Service Bulletin

Bulletin No. 2014-08
OEM No. 2014-03

L6 Verado Powerhead Base Gasket Replacement

a - Green paint mark

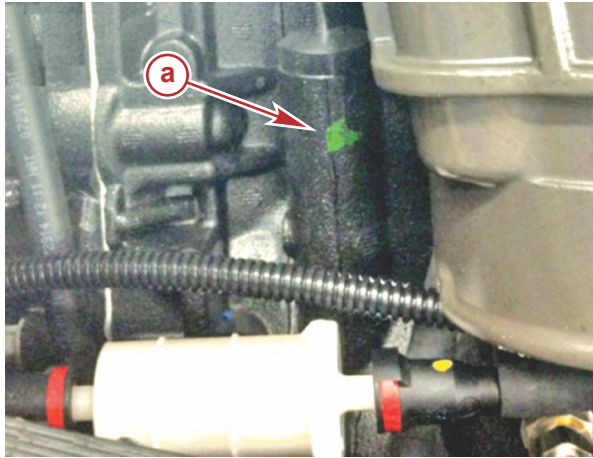
- A green paint mark is applied to the cast boss that retains the dipstick which is located on the port side of the engine.
